ADDRESS . . : 150 BLUEBONNET OAK CT
 CONTRACTOR : CAVINESS LAND DEVELOPMENT
 OWNER . . : WOODSHIRE PARTNERS LLC
 PARCEL . . : 01-0536-05- -0028- -71-
 APPL NUMBER: 09-50023332 CP NEW RESIDENTIAL (SFD)
 DIRECTIONS : T/S: 12/01/2009 09:14 AM VBROWN ----
 FOREST OAKS SUB DIV PH3 #184, IN
 CUL-DE-SAC, BLUEBONNET OAK COURT. 27W,
 LEFT ON NURSERY RD, LEFT ON WOOD POINT
 DR, RIGHT ON KIMBROUGH DR, LEFT ON BLUE
 OAK DR, LEFT ON VALLEY OAK DR, LEFT ON
 BLUEBONNET OAK COURT, #184 IN CUL DE
 SAC.

Reference: Engineering Services
Lot 184, Forest Oaks
Harnett County, NC
Project No.: 10GAR-F0556

As requested, a representative of Tyndall Engineering & Design, PA (TE&D) has analyzed the following foundation items for the above referenced project:

JOB LOGAR- F0556
 LOCATION Lot 184, Forest Oaks, Hargett Co. NC
 CALCULATED BY P.T. DATE 6/24/10
 SHEET NO. 2 OF 2
 SCALE AS IS

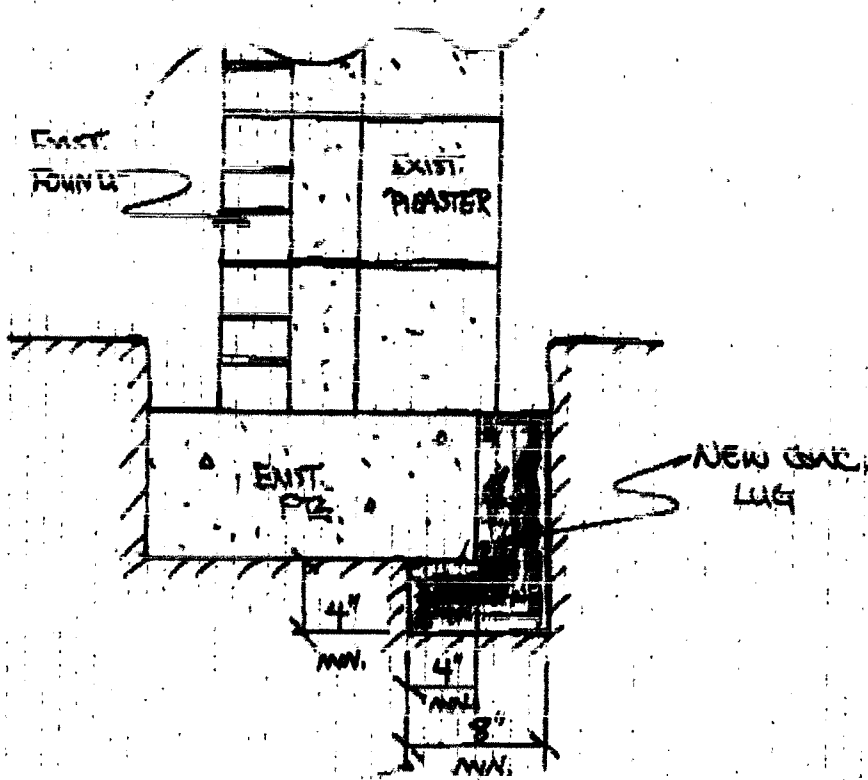
- 1) Recommend a footing/foundation projection repair for the pilaster along the left side of the dwelling.
- 2) Analyze and comment on the adequacy of the footing/foundation projection for the three (3) pilasters along the right side of the dwelling that had been backfilled prior to the Inspector's arrival.

- 1) The undersigned TE&D representative recommends that the footing/foundation projection be enhanced by constructing an additional concrete lug adjacent to the existing footing. The reader is referred to the attached diagram.
- 2) The existing footing projection was exposed by the footing contractor. The existing projection was adequate to support the anticipated loading conditions. No remedial action required.
